Comments received by the Division for the Seeley Reservoir Stockpiles M-2023-043 Application

RE: Seeley Reservoir Stockpiles, File No. M-2023-043 (Adequacy Review/Additional Application Comments)

**RE: Review of the Ogilvy Ditch Company
Structure Keirnes Land Company, LLC/Eagle
View Farms, LLC Weld County, Colorado**

Exhibit 1 (Continued) Images # 1 - 4

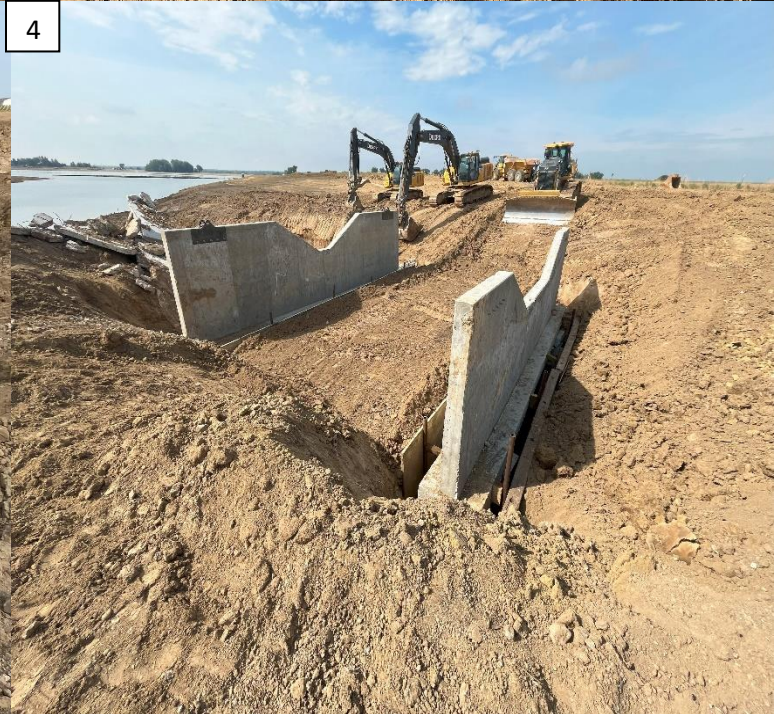
- Image 1 - Shows the first unapproved failed structure and damages caused, due to the non-engineering (as stamped engineered plans were nonexistent). Our general observations contradict the claimed cause of failure and we believe it was due to head wall pressure by damming up the historical flow of water.

- Image 2 - Shows the 2nd structure utilizing the salvaged headwall set on crushed concrete, elevated 4ft +/- resting on concrete blocks (neither of these components are shown on engineered drawings), skewed/moved outside of the historical flowline.

- Image 3 – Shows formed footers via railroad ties on top of crushed concrete, with no horizontal rebar or vertical rebar ties connecting the salvaged headwall.

- Image 4 – Shows uncompacted back fill and no compaction test nor mechanical compaction were provided or verified.
- Image 5 – Shows the railroad tie forms left and backfilled in place and again no mechanical compaction were provided or verified.

Exhibit 1 (Continued) Images # 5 - 8

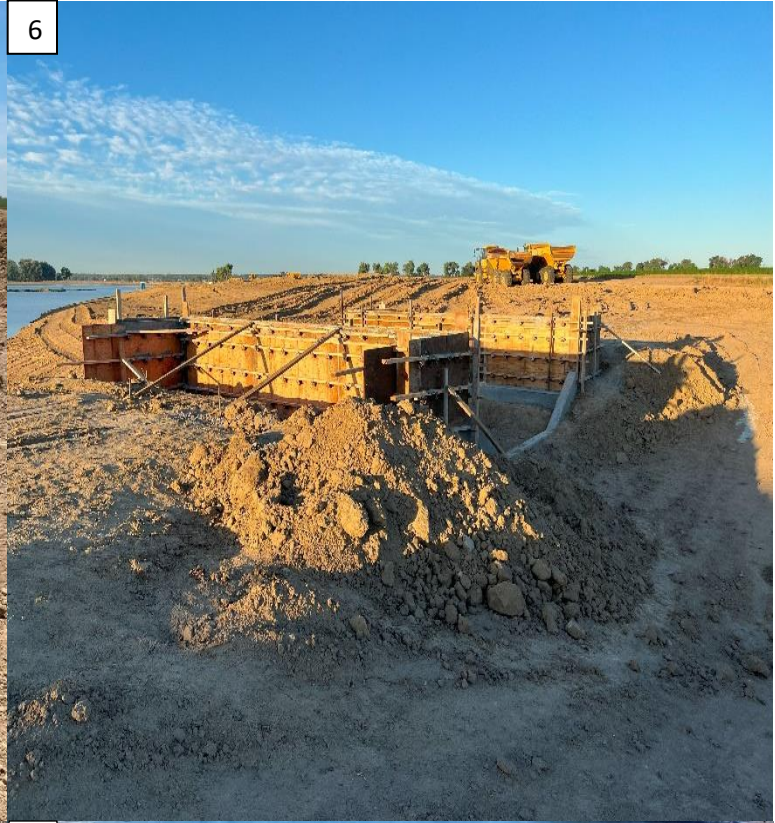
- Image 6 – Shows skewed forming of unneeded height on top of headwall making the overall height of the structure 11 ½ ft top to bottom.
- Image 7 – Shows historical flowline altered and moved west during construction (see Image 8 for historical context). It shows the new detained/impounded body of water footprint (5ft deep x 50ft wide x 1000 ft long). The gross magnitude of the structure (7ft + above HWL) and the impounded body of water upstream of the Seeley Lake Reservoir is not justifiable per our third party engineer.

- Image 8 – Show the subject areas' historical positive flow of water down gradient to the Seeley Lake Reservoir, before creating the new detained body of water outside of the reservoirs original foot print shown in image 7.
